PRODUCT CHANGE NOTICE

PCN25-006

Correction of typo on Web Datasheet for PIN 1 Location

AFTER:

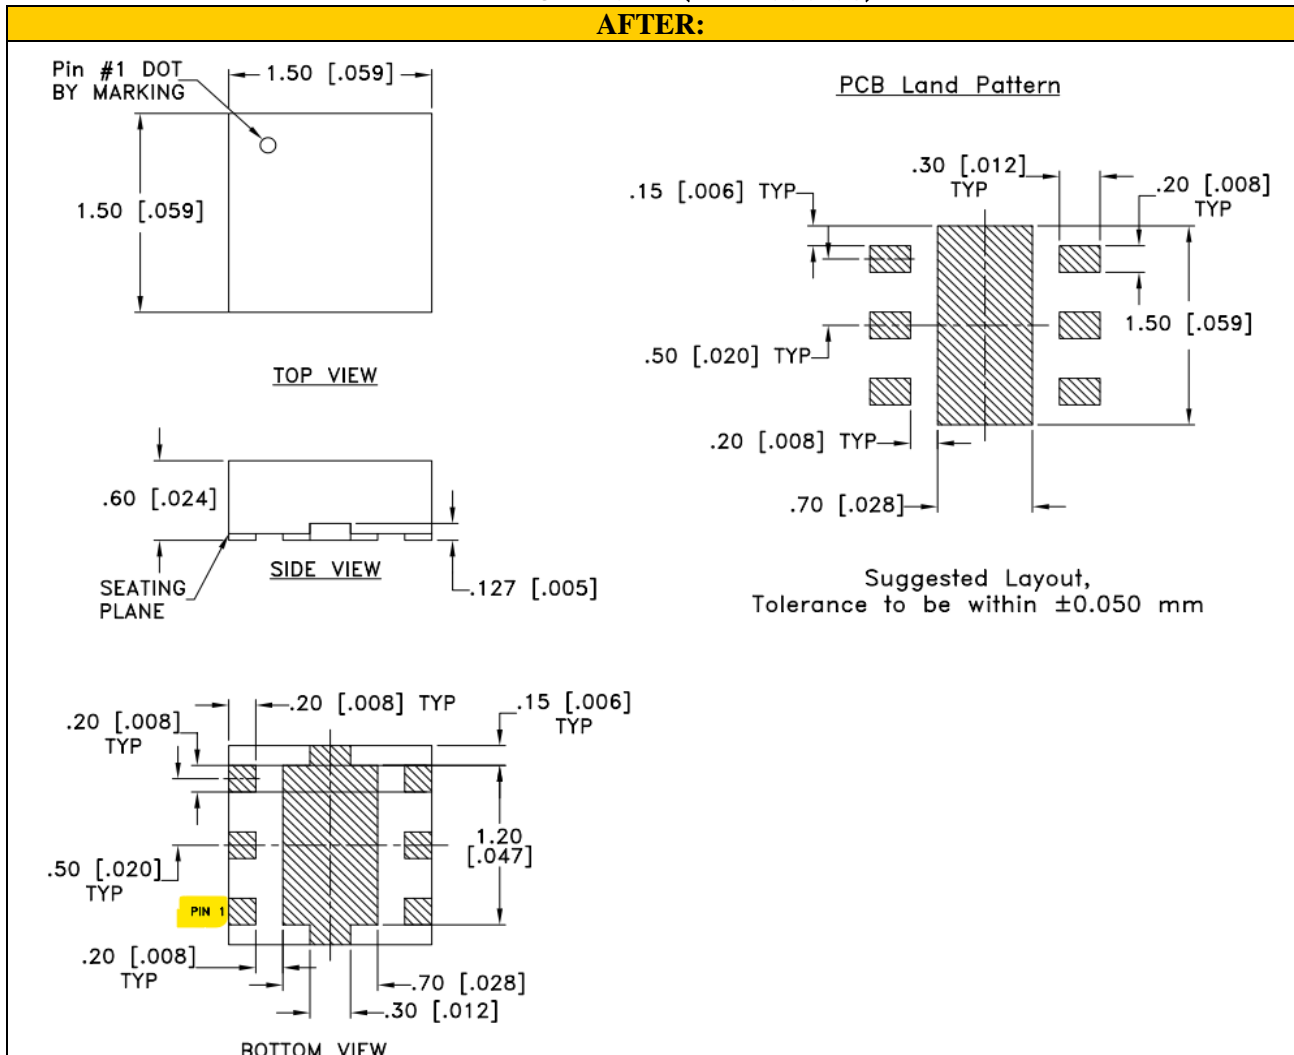
No physical change to the device FIT, FORM or FUNCTION. Correction of drawing

Correction of Error in original web datasheet
